Kenilworth VI

Clinton, Connecticut

REPORT

Review Date: JANUARY 8, 1987

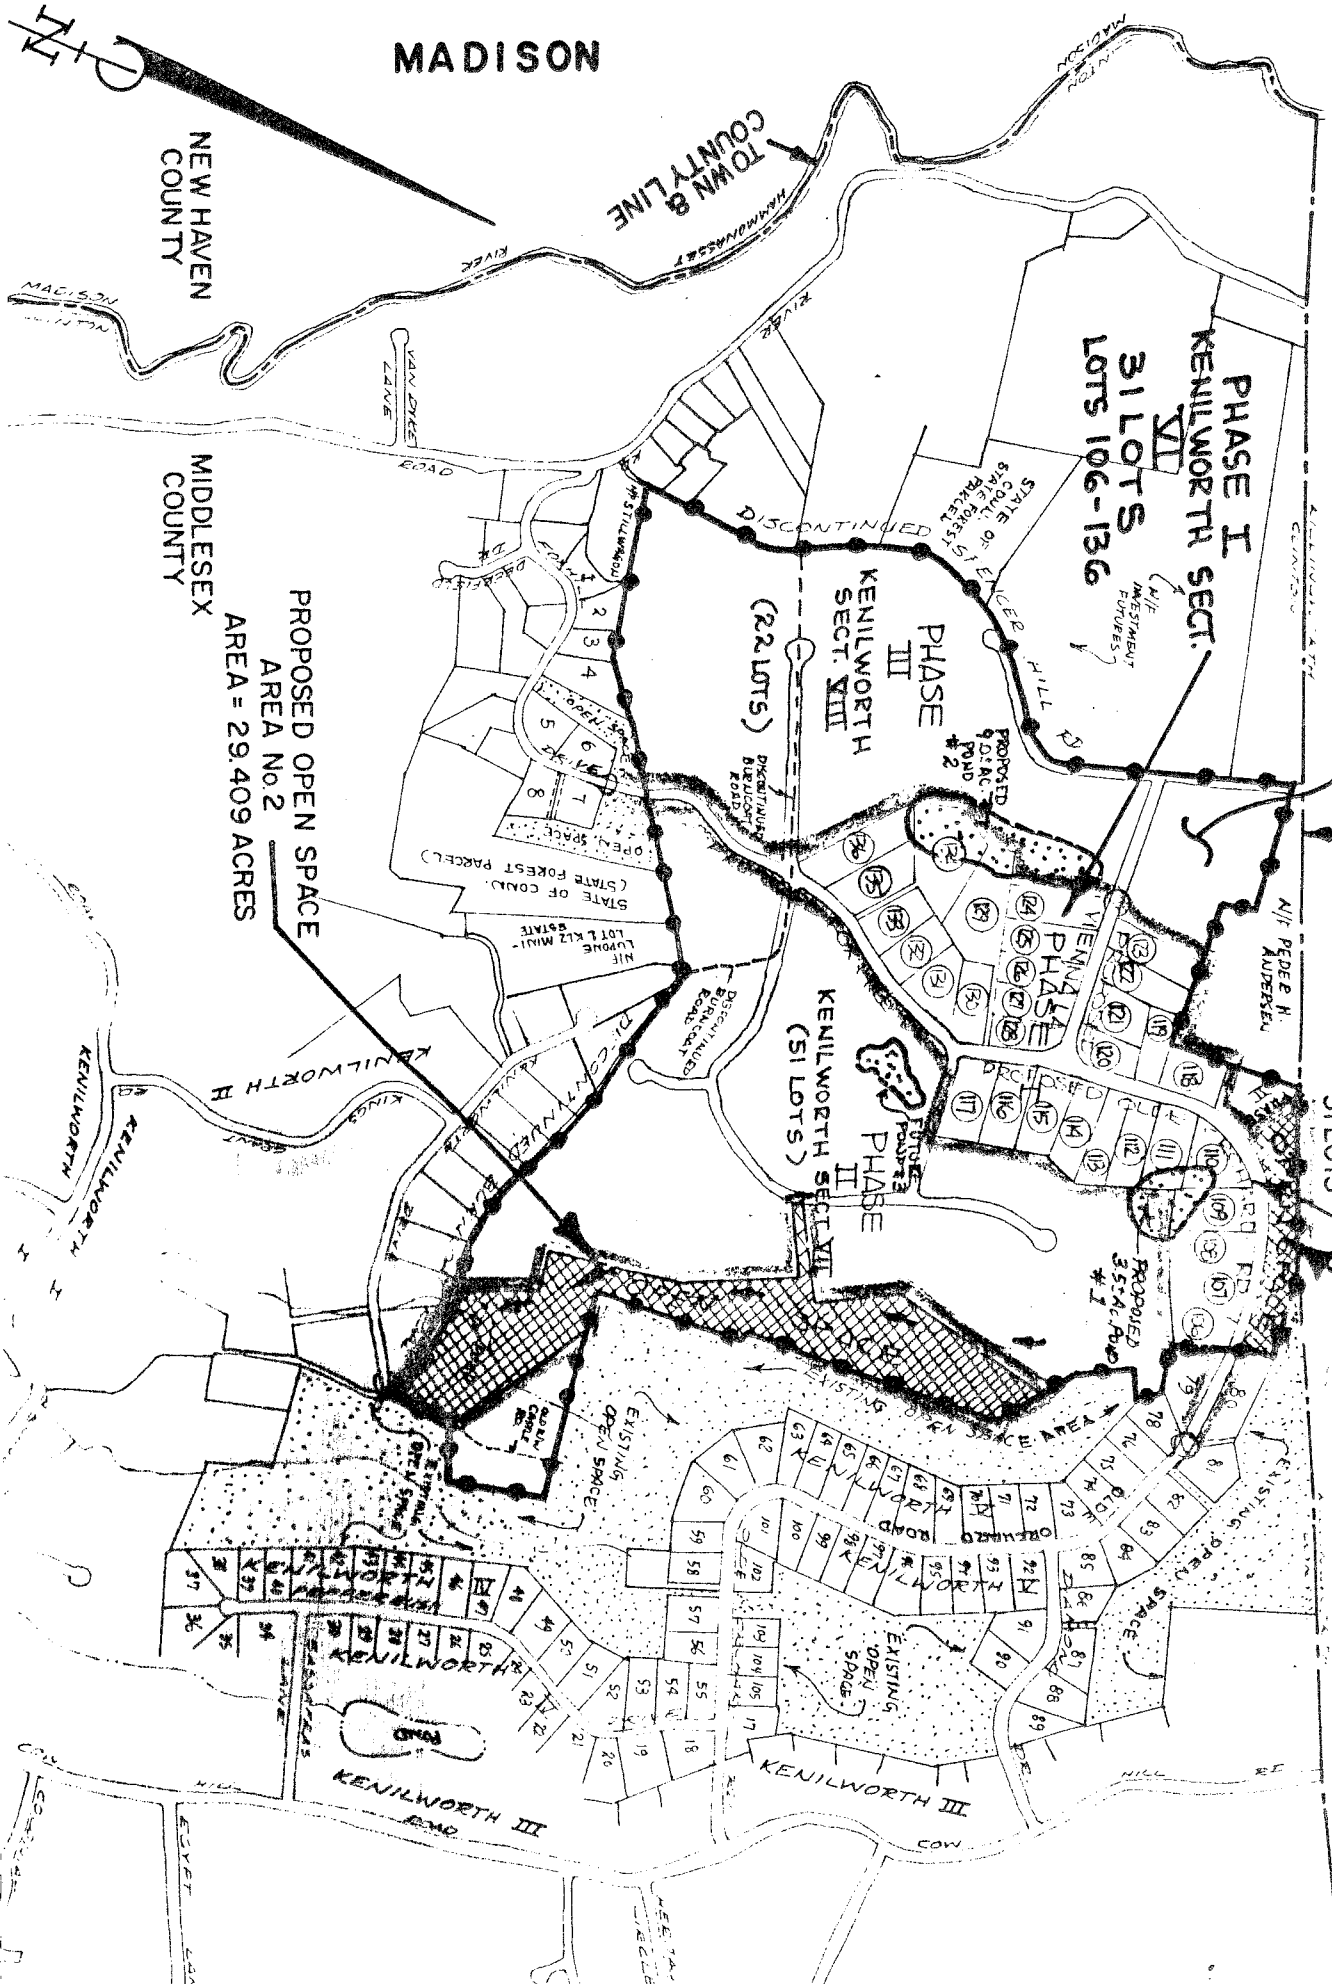
All three (3) ponds appear to have drainage ratios less than 10 to 1, and the amount of groundwater recharge is undocumented. The proposed sizes for ponds 1 and 2 seem excessive, and it can be expected that surface evaporation can be larger than recharge, especially during the summer months. For this reason, it is recommended that the pond sizes be reduced to reflect more closely the expected needs of the fire department. For instance, a pond with a surface area of one acre that is one foot deep will hold approximately 325,850 gallons of water. The same pond, but 8 feet deep, will hold over one million gallons of water. How much water does the fire department envision they will need?

It is recommended that pond construction be limited to the flatter sections of the wetland. Where there is a significant slope along its length, such as at pond #2, the pond should be designed to be wider and not as long. If needed, a series of smaller ponds at different elevations could be constructed. Wildlife and safety should be considerations in designing the ponds.

Extensive subsurface exploration of Phase I (Proposed 31 lots) has been performed by Kenny and Steven engineers. The work involved deep test holes, generally 6 to 9 feet deep. They typically encountered a top soil layer, a weathered and rooted subsoil to 2 to 3 feet, and then hardpan. Possible shallow ledge conditions (less than 5 feet below ground level) were reported in a few test holes. Further testing should be conducted on these lots to determine whether or not shallow ledge conditions actually exist. There is a chance that depth of ledge will be an important design constraint in these areas. The subsurface sewage disposal report prepared by the project engineer indicates that conditions are generally suitable for subsurface sewage disposal. Engineered septic systems would be required on all lots. Geologic conditions on the remainder of the proposed subdivision appears to be similar to Phase I. No subsurface data for these areas were available on the review day. Based on observations made during the field walk, it appears that suitable conditions for engineered septic systems will be found on most of the lots. However, a detailed lot by lot investigation will be required. Such an investigation may result in some rearrangement of lot lines in future phases. (For further sewage disposal information see Section 8).
